City of Santa Fe, New Mexico

memo

2025-011325-HDRB, 119 Camino Santiago, Downtown & Eastside Historic District, Contributing, John Padilla, agent for Dominic Serna, owner, proposes to replace windows and doors, construct a 5' yard wall with gate and a 6' coyote fence, infill two doors, construct an enclosure, reconstruct the portal, roof, and stucco, Exceptions are requested to 14-5.2(D)(5)(a)(i) for replacing historic windows and doors, 14-5.2(D)(5)(b) for altering the portal of a primary facade, installing a fence and gate on a primary facade, and 14-5.2(D)(2)(d) for the enclosure under the portal.

Figure 3: Façade diagram for 119 Camino Santiago

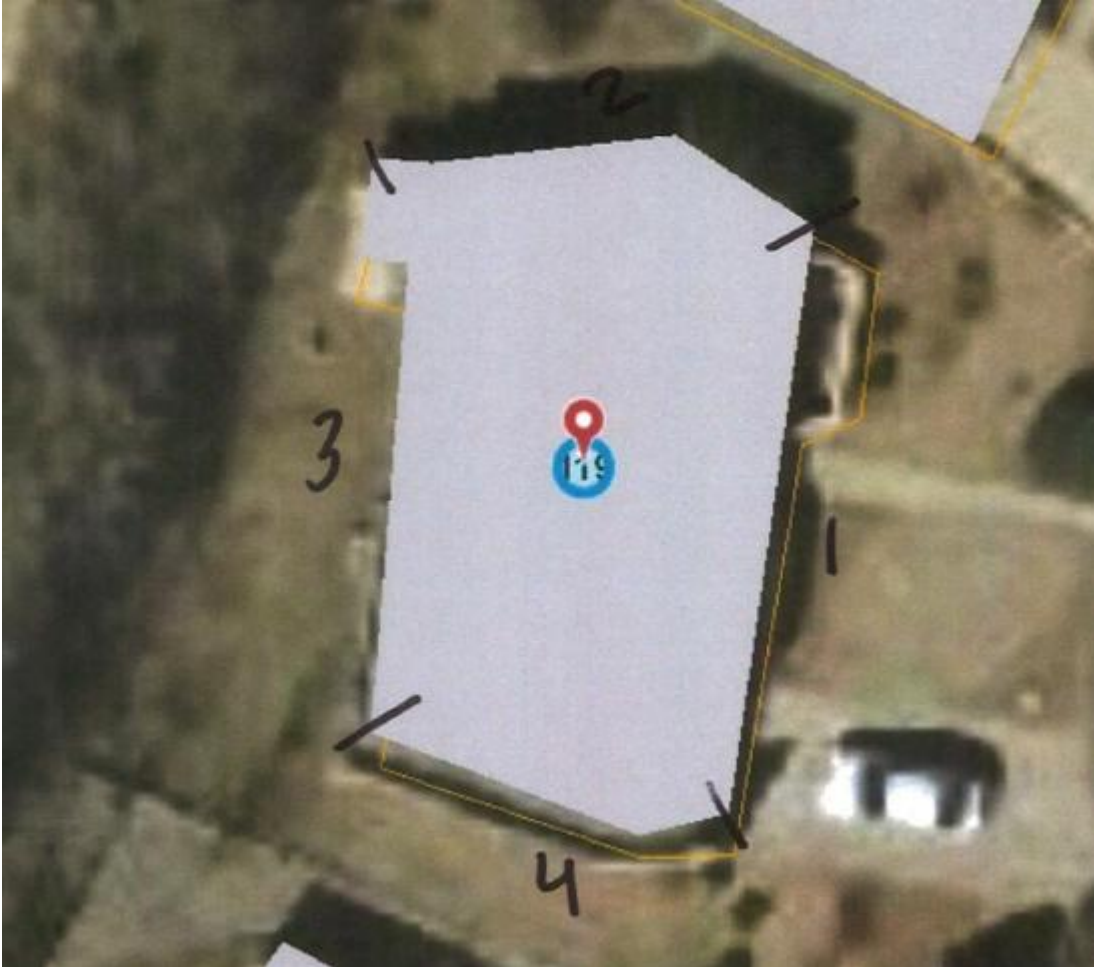
All structures in Plaza del Monte were assigned statuses under cases H-17-098A and H-19-019 in 2018 and 2019. In 2019, under case H-19-019, the residence at 119 Camino Santiago was designated as contributing with the east (1) and south (4) facades as primary because the structure is a good example of Mid-Century Modern Santa Fe Style (low projecting roofline and south fin wall as character defining) and because of its association with Plaza del Monte, a master planned community by architects Clark and Register. The board specifically stated the wall in front of the entry is part of the façade and is significant in design, and the low projecting viga element is primary.
